Product Change Notice (PCN)

Subject: Change PCB Supplier for Flow Sensors Products

Publication Date: 7/1/2021

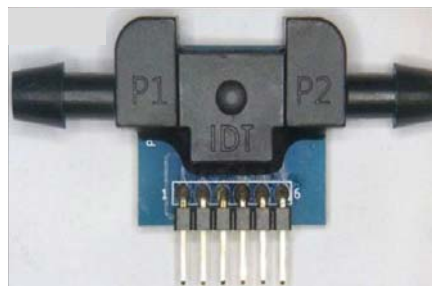
Renesas is changing to a new PCB supplier as a result of the current PCB supplier had discontinued the business for flow sensors products. Refer below table for the comparison of the current supplier versus the new supplier as well as the comparison of the current solder mask versus the new solder mask.

The change will have no impact on the function, quality, reliability and environmental compliance of the products. However, the form and fit are changed as depicted in page 1.

Solder mask color where blue denotes new PCB whereas dark blue denotes old PCB.
